REGENCY LAKES

AN ADDITION TO WICHITA, SEDGWICK COUNTY, KANSAS

RE: S/D 96-22, Final Plat of the Regency Lakes Addition

CASE NUMBER: S/D 96-22 REGENCY LAKES ADDITION

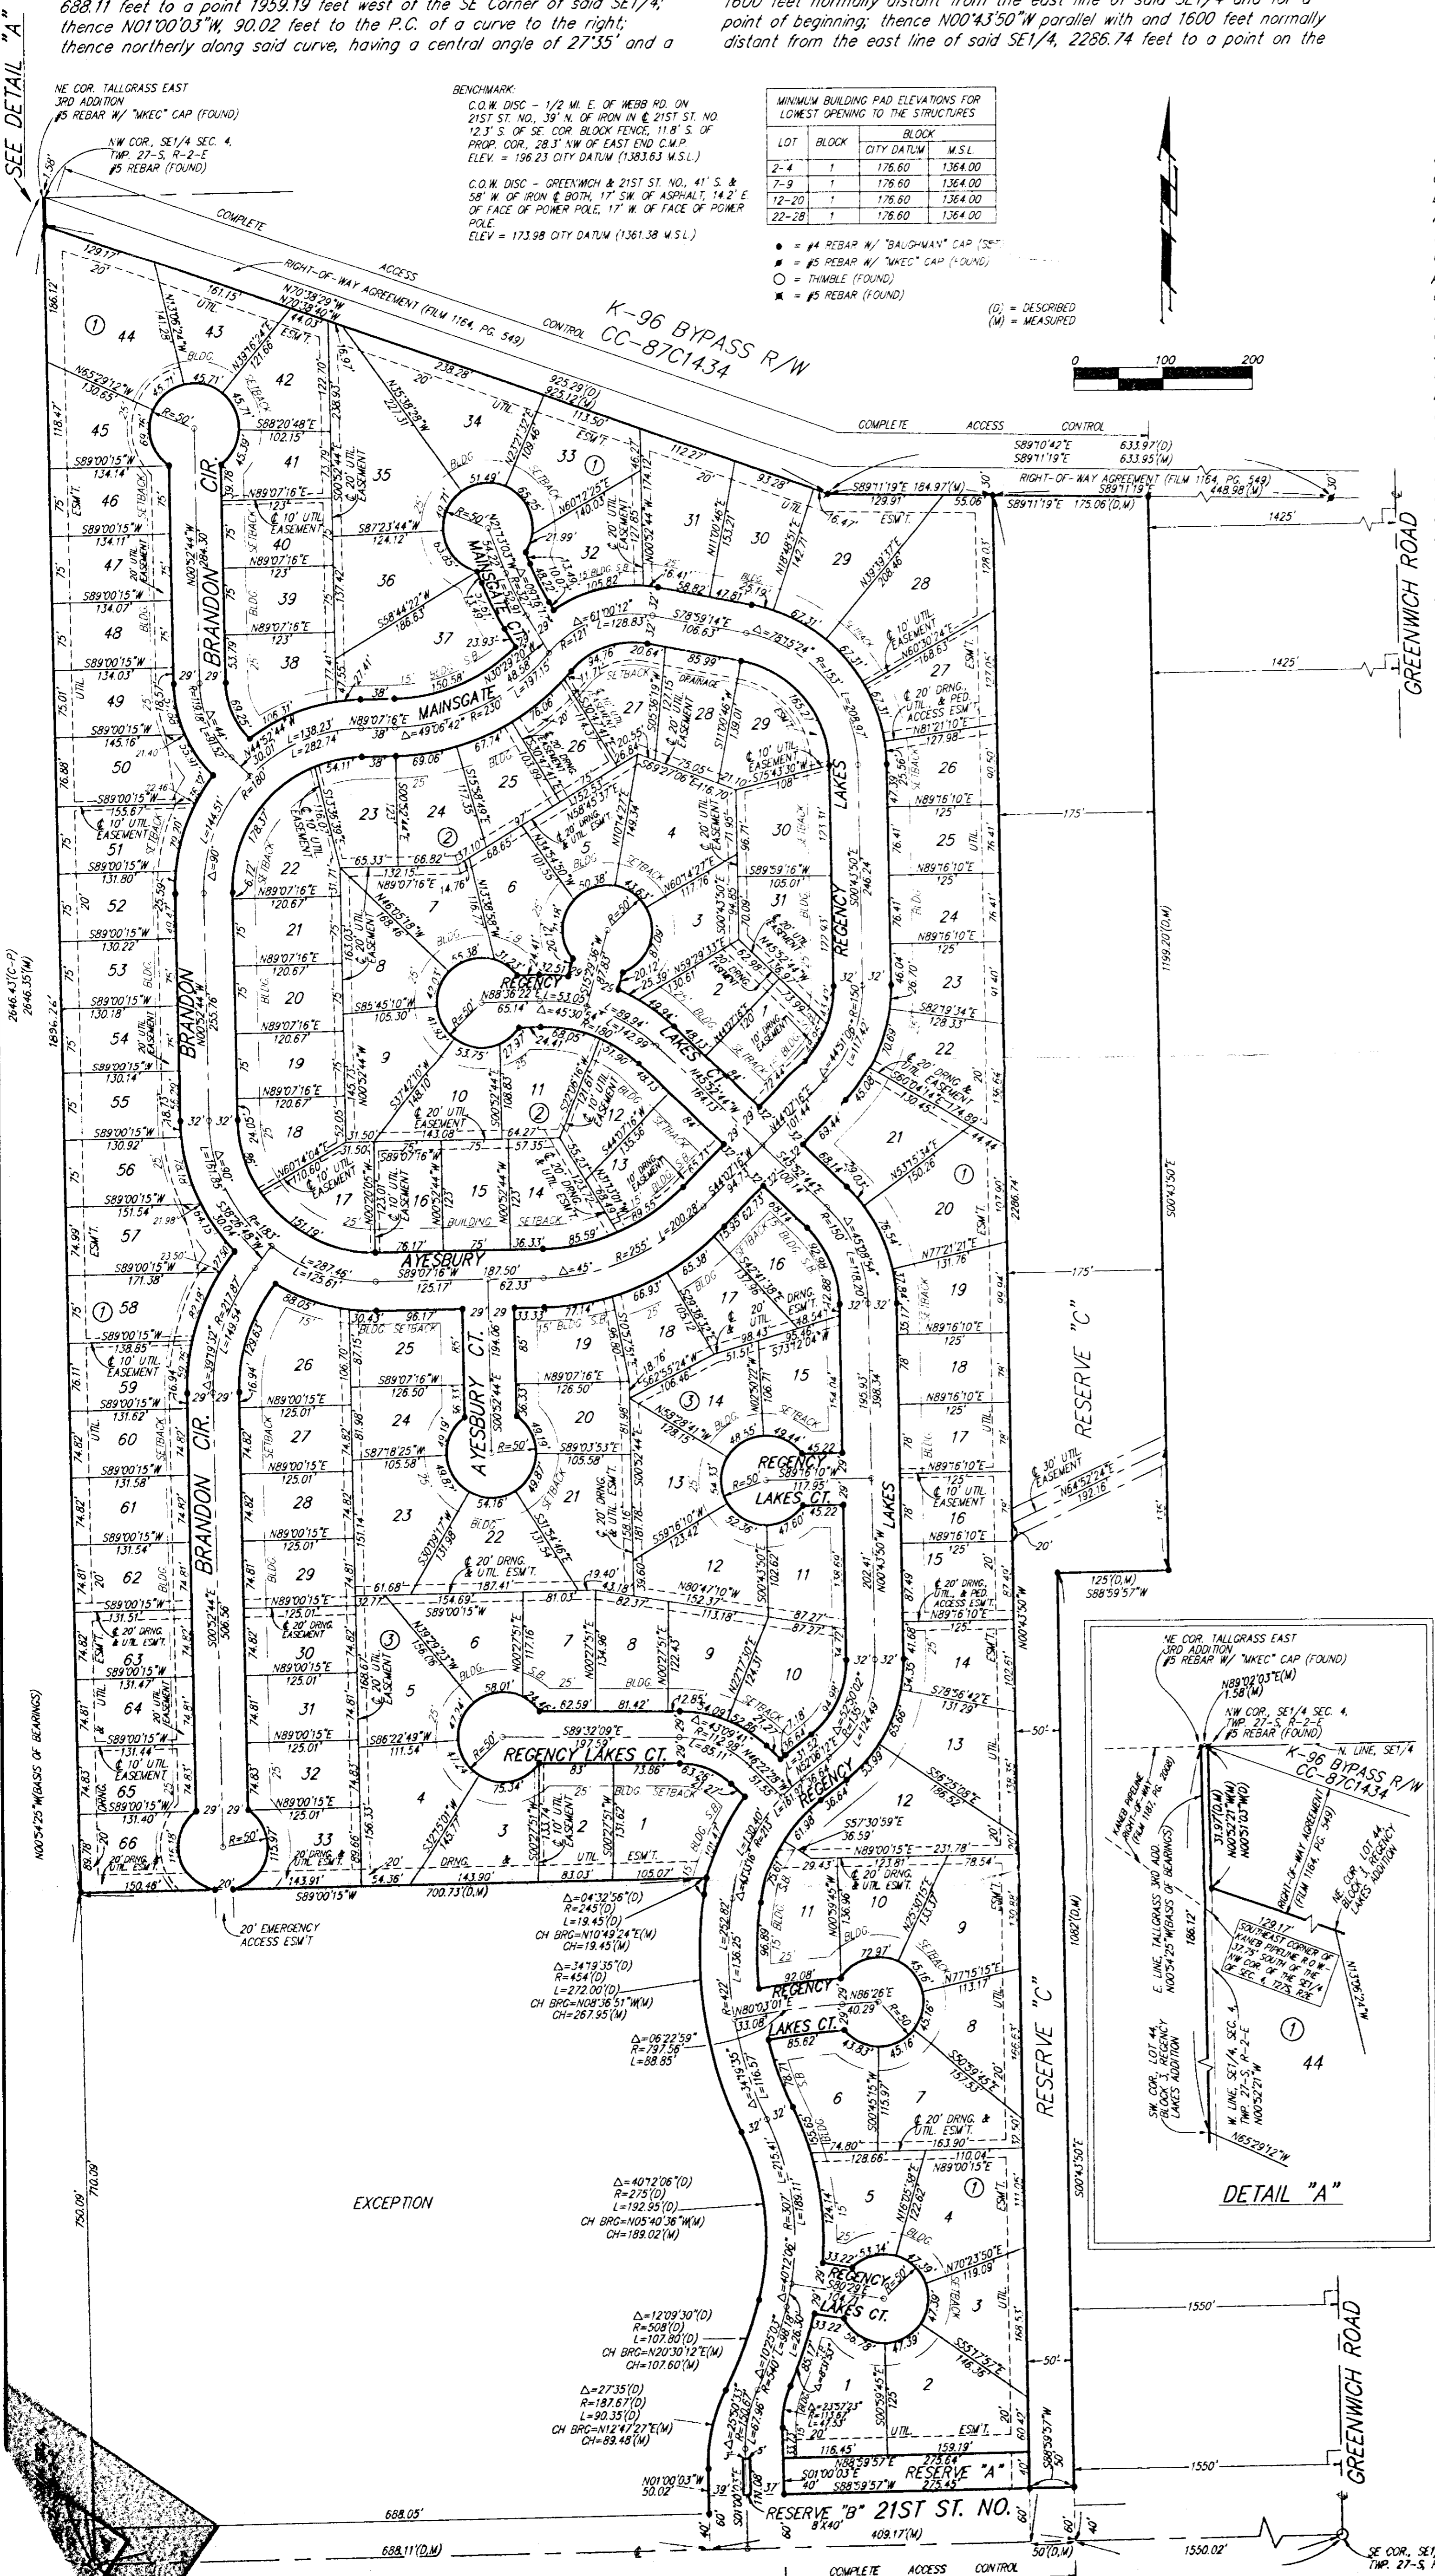
- A. As requested by the applicant, the final plat tracing may include, as a Reserve, the area along this plat's east line. The plat shall note the purpose or uses for this Reserve. Also, at least 2 or 3 means of access shall be provided from this Reserve, westward into the residential areas.

- C. The applicant shall guarantee the extension of sanitary sewer to serve the lots being platted. As noted by Planning and City Engineering, sewer service may not be possible at this time and completion of this plat to the City Council may be subject to the availability of sewer to this site. As needed, off-site utility easements shall be provided for extension of sanitary sewer.

- D. The applicant shall guarantee the extension of City water to serve the lots being platted. The applicant needs to contact the Water Department and City Engineering to determine if and how this site can be served at this time.

- E. The applicant shall guarantee the paving of the proposed interior streets. In addition, this guarantee shall provide for sidewalk on at least one side of all non-cul-de-saced streets.

20 F. As noted by Traffic Engineering, guarantees shall be provided for a left-turn lane in 21st Street and a right-turn lane from the site to serve the development's entrance at 21st

W. As requested by County Engineering, the final plat tracing shall dedicate 60 feet of right-of-way for 21st Street North (FAS route).

X. The final plat tracing shall indicate minimum building pad elevations for lots along the plat's east line, adjacent to the detention facilities.

Y. As requested by KG&E-Electric, the final plat tracing shall grant additional, 10-foot utility easements along the following common lot lines: Lots 58 and 59, Block 3, Lots 16 and 17 and 26 and 27, Block 2.

- J. Since this site is now indicating only one point of access (Conceptual Plan indicated at least one additional point of access at this plat's northeast corner), for 131 residential lots, with some lots being over 2,000 feet from the site's 21st Street entrance, the applicant shall provide a means of emergency access for this development. Such access needs to be reviewed and approved by the City's Fire Department, with appropriate assurances provided for by the installation and maintenance of any improvements deemed necessary.

- M. The final plat tracing shall indicate the street names requested by the City's Fire Department.
- N. The applicant is advised that the configuration of Lot 6, Block 2 is somewhat awkward and may significantly hamper the positioning of a home on this lot.

Phil M. noted that certain off-site easements for this plat will be provided by the borrower, Bus AK plat is hold this plat so that it can go with that plat

Being provided by Greenwich Street
1104 -> so 1/2 1/2

not listed on plat. Phil says was a dual left turn from site to 21st not an accel along 21st
